KANSAS GAS AND ELECTRIC COMPANY

KMLNRC 85-058
Re: Docket No. STN 50-482
Ref: (1) Letter KMLNRC 84-238, dated 12/31/84
from GLKoester, KG&E, to RCDeYoung, NRC
(2) Letter KMLNRC 85-037, dated 1/21/85 from
GLKoester, KG&E, to RCDeYoung, NRC
Subj: Supplemental Information on Structural Steel Welding

RE: Evaluation of Structural Steel Welding at Wolf Creek - CAR No. 19

Re: Structural Steel Welds at
Wolf Creek Generating Station

Fig a

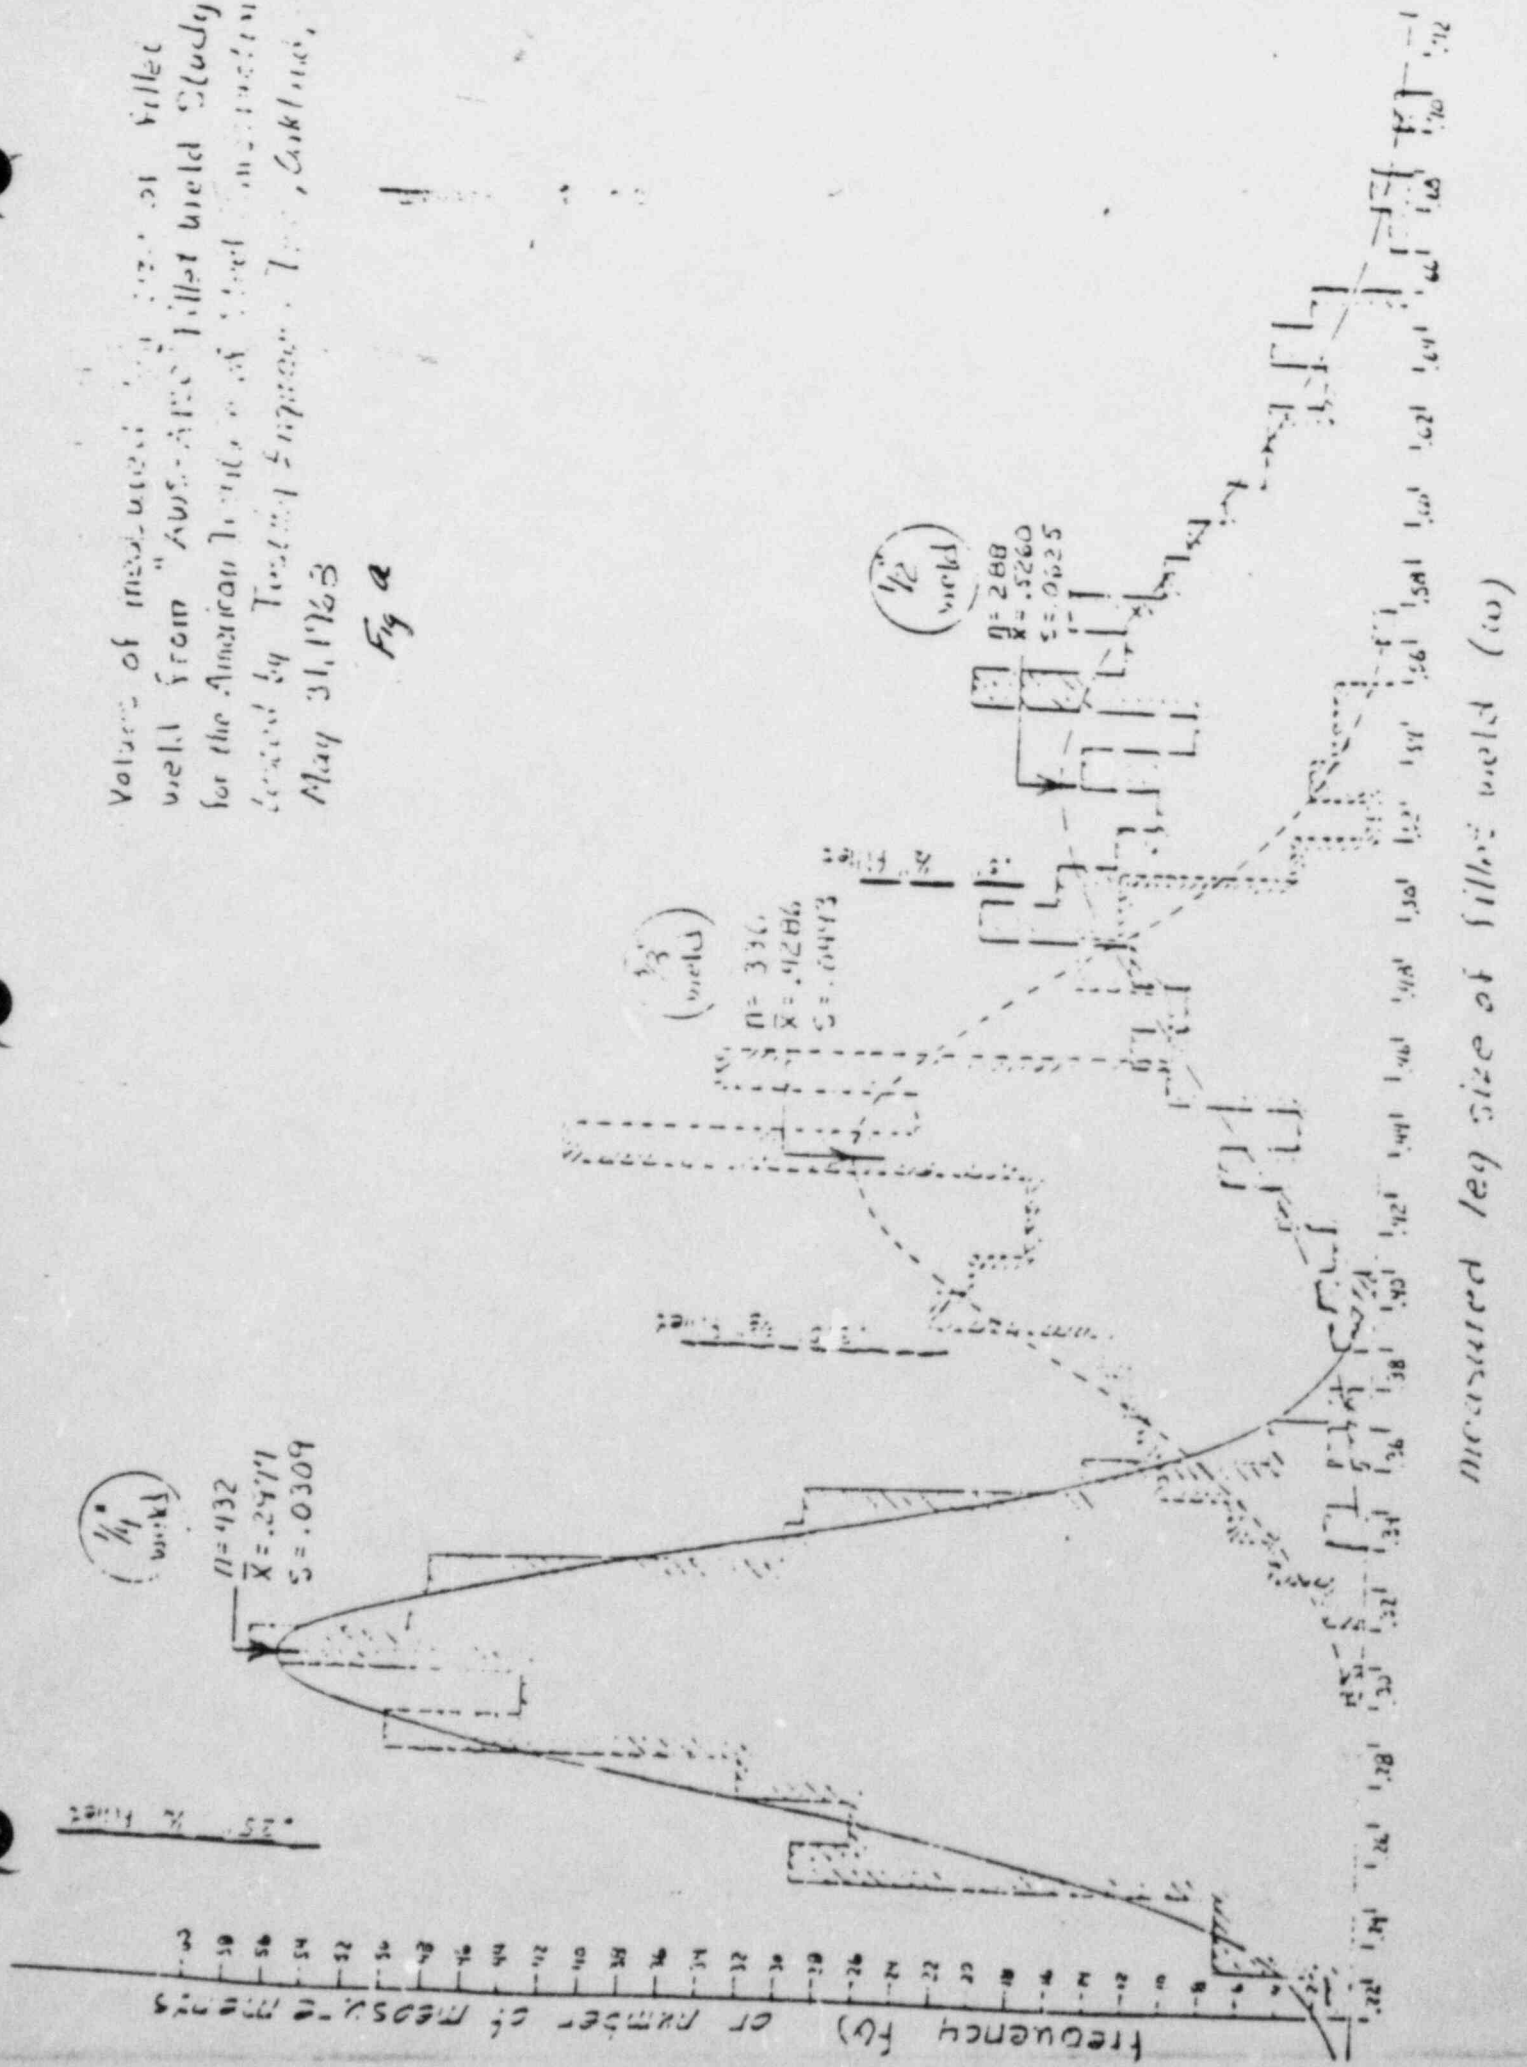
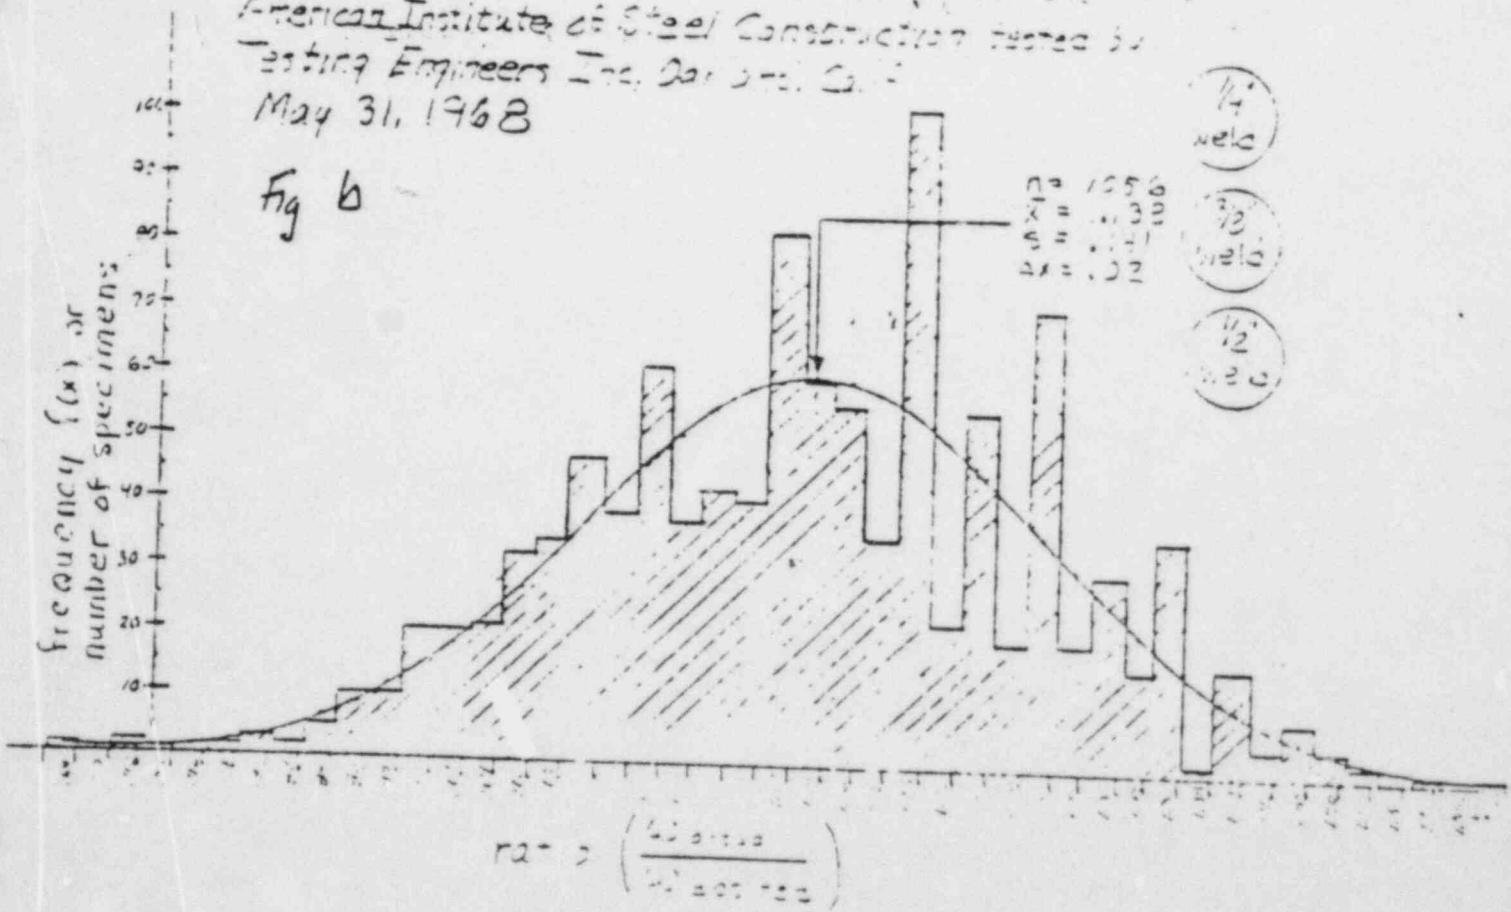
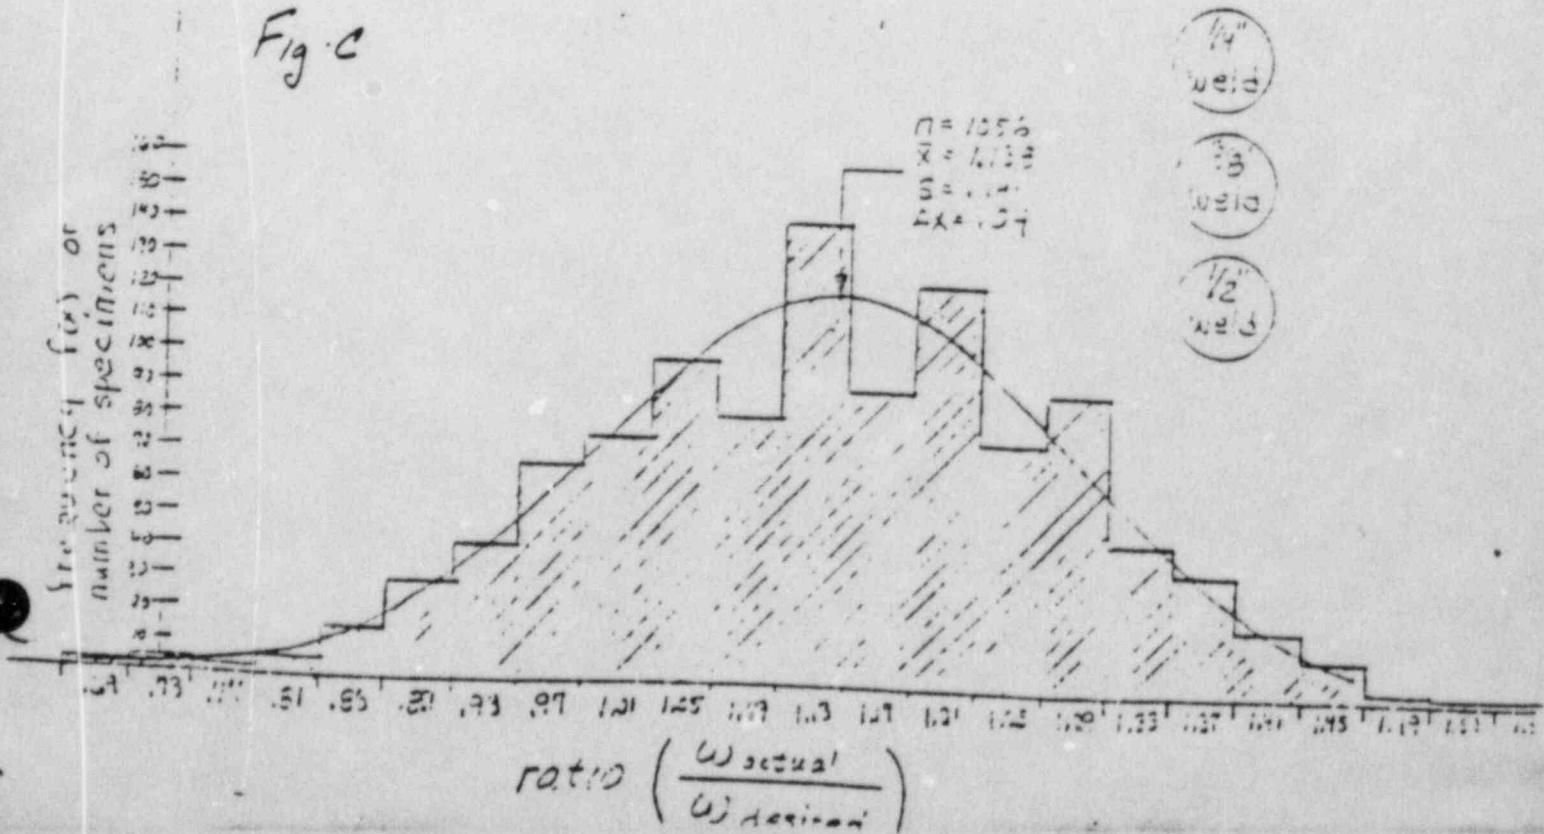
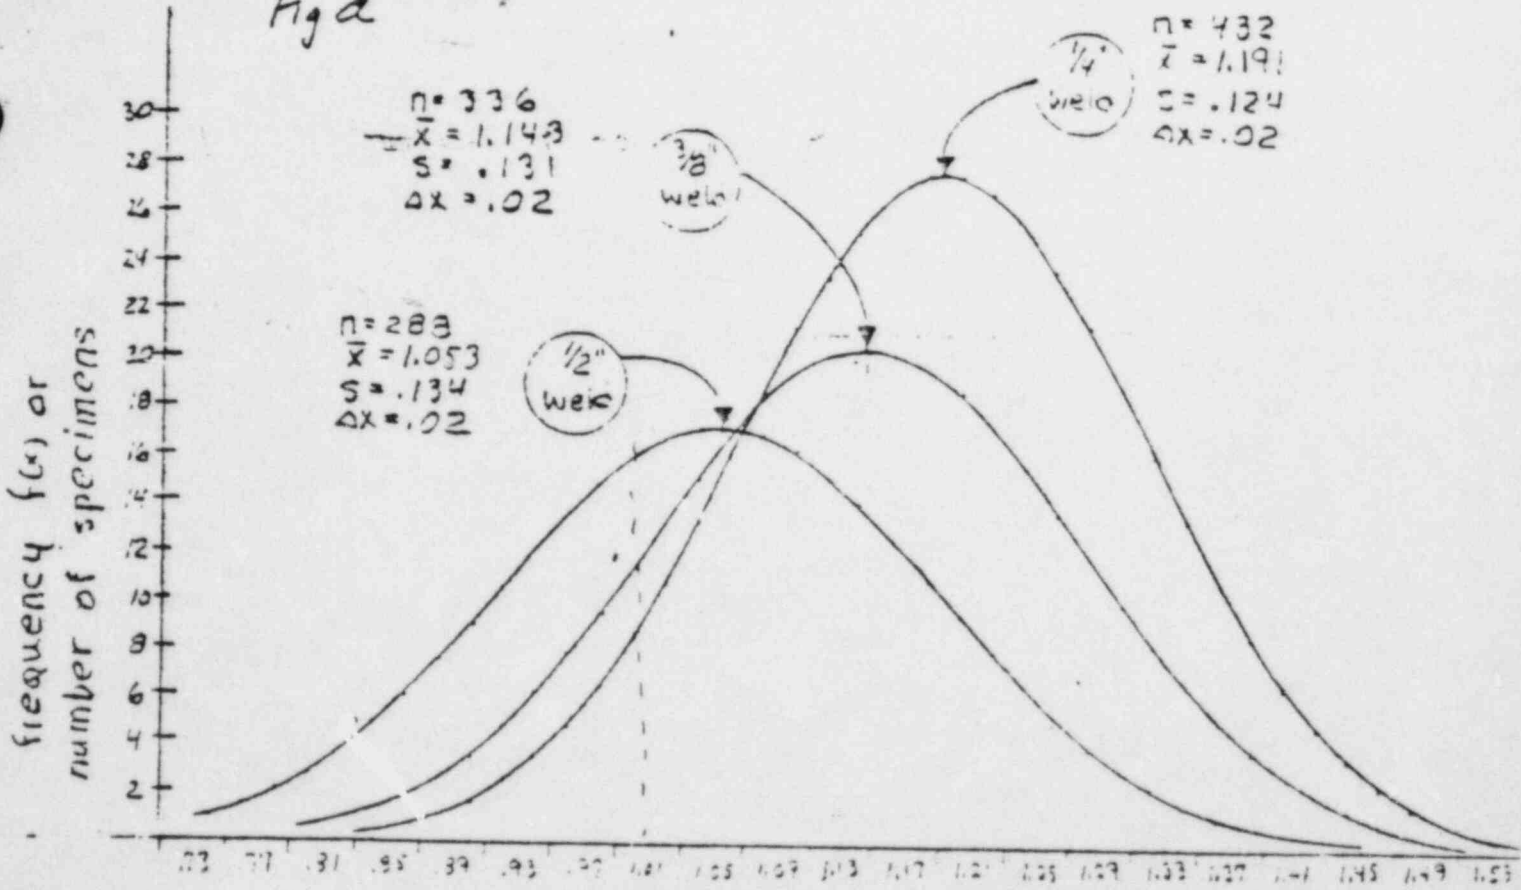
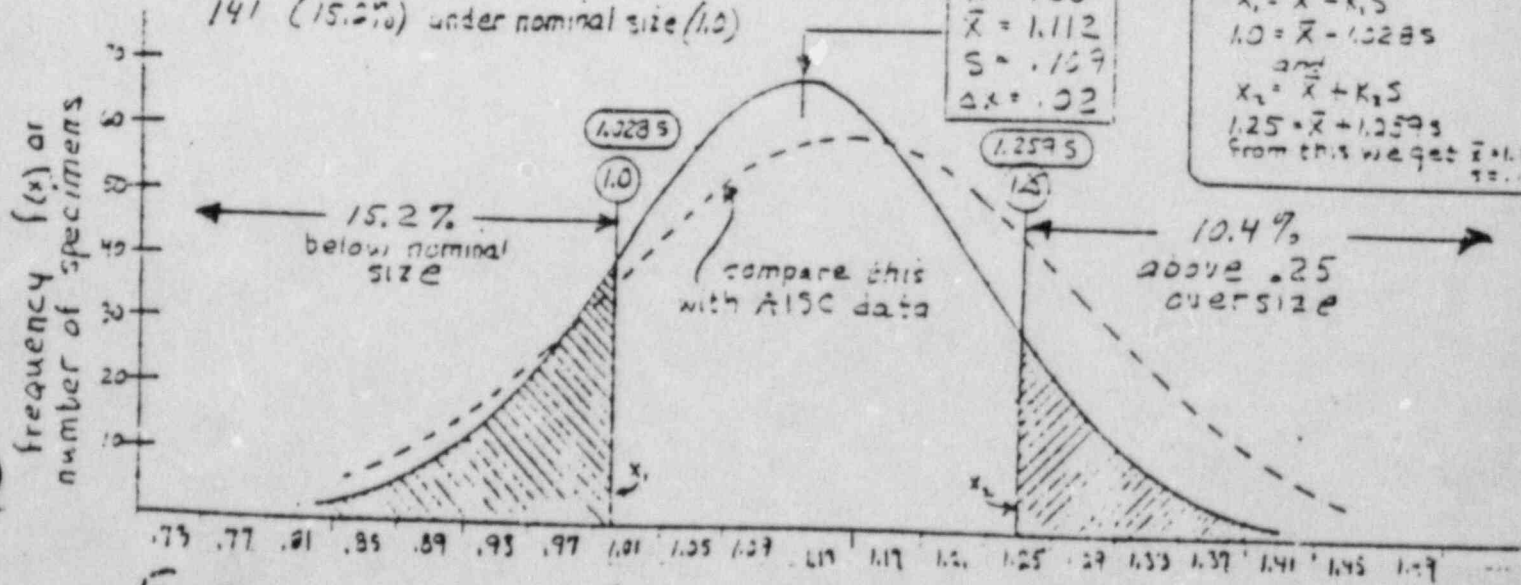
The general problem of weld size should be considered in terms of the expected statistical variation of weld dimensions in typical structural welding where the AISC allowable stresses are applicable. Enclosed are Fig. a through Fig. e showing the statistical variation of the 1/4 in., 3/8 in., and 1/2 in. welds used to develop the AWS and AISC specification provisions. These curves show the deviation in weld sizes that are to be expected with production welds. The variation of weld capacity that resulted from the AWS-AISC fillet weld study in 1968 was in part due to the variation in weld size that existed with the test sample. These were normal production welds, and similar deviations will exist with all welds. Figure 19.3 in Structural Steel Design shows the shear strength based on nominal weld size. It is clear that part of the reason for the variation in capacity is based on the weld size variation.

When a weld is found to be undersize by measurement, it is not significant unless it falls below the range indicated by the curves. The AWS Specification does not address the problem of deviations, and disposition of undersize welds must be done using the type of analysis that Bechtel has proposed. The fact that they are using actual weld sizes in calculations is conservative, since the specifications used the lower bound of the test data which included weld undersize.
